**TECHNICAL EVALUATION REPORT
(Non-Proprietary Version)**

**An Advanced Computer Program for Light Water
Reactor LOCA and Non-LOCA Transient Analysis
BAW-10164P, Revisions 2 and 3**

**W. C. Arcieri
D. A. Prelewicz**

March 1995

Figure H.1. RELAP5 Model of Hypothetical Reactor Core.

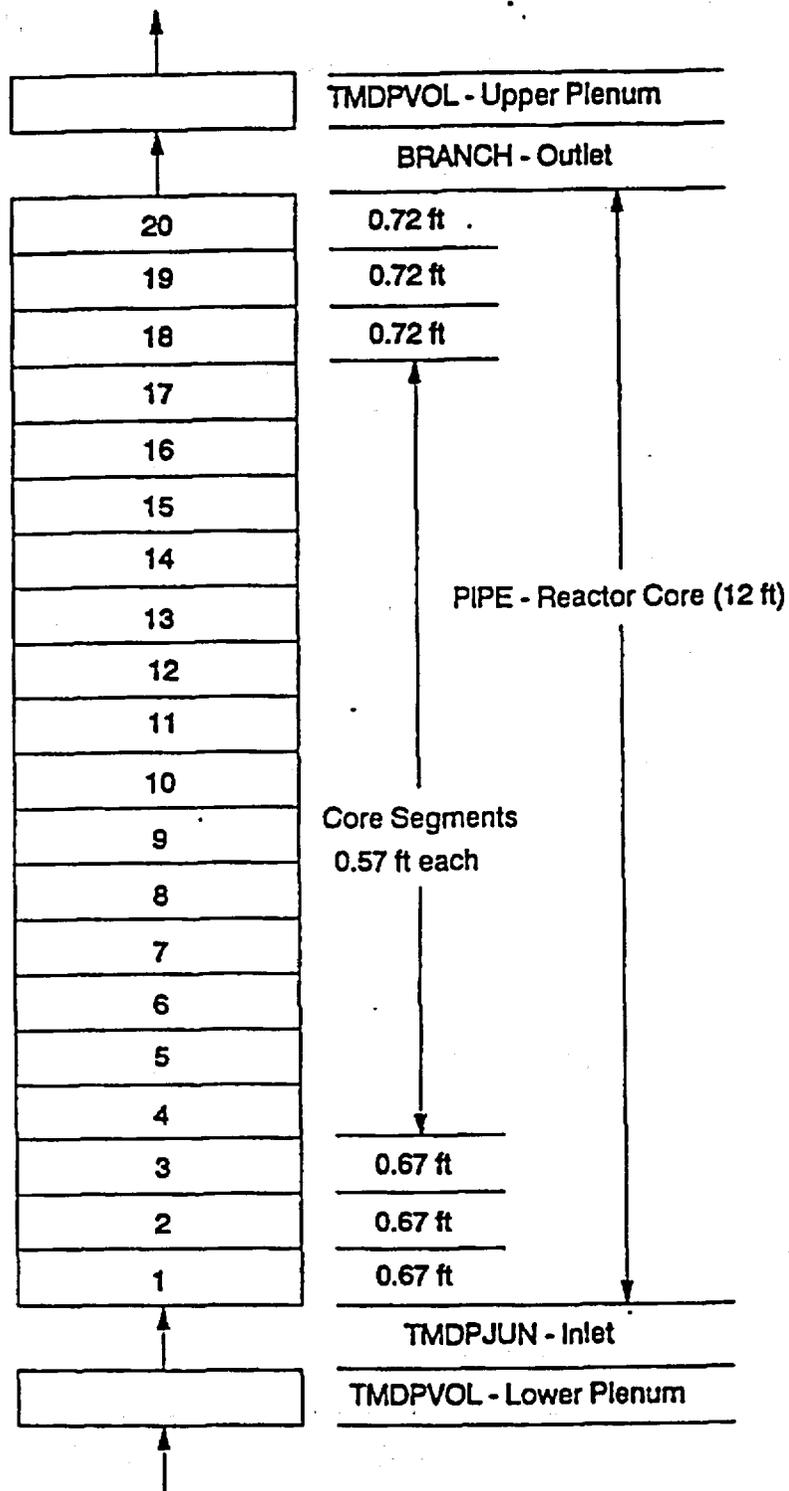
Affected Report Revision and Section	Change Summary
Revision 2, Appendix H, Figure H.1	Correction to Figure H.1 in response to Question 2 of the Revision 2 RAI
Revision 2, Appendix H, Table H.2	Correction to Table H.2 in response to Question 4 of the Revision 2 RAI
Revision 2, Section 2.3.3 and Appendix I	Correction to Equation I-1, I-2 and pressure and mass flux units in response to Questions 5, 6, and 7 of the Revision 2 RAI
Revision 2, Appendix I, Table I.3	Duplication in point numbers in Test 160 (point 789) and Test 164 (points 2060 and 2065) should be corrected or clarified.
Revision 2, Appendix J, Page J-8	Reference to Table 2 should be Table J.2 per Question 11 of the Revision 2 TER
Revision 3, Section 2.3.2	Correction of ϵ_{TC} value on Table 2.3.2-2 in response to Question 4 to the Revision 3 RAI.
Revision 3, Page 2.3-46	Correction to β^2 definition in text in response to Question 5 of the Revision 3 RAI. Other correction noted by BWNT on Page 2.3-36 should also be included.
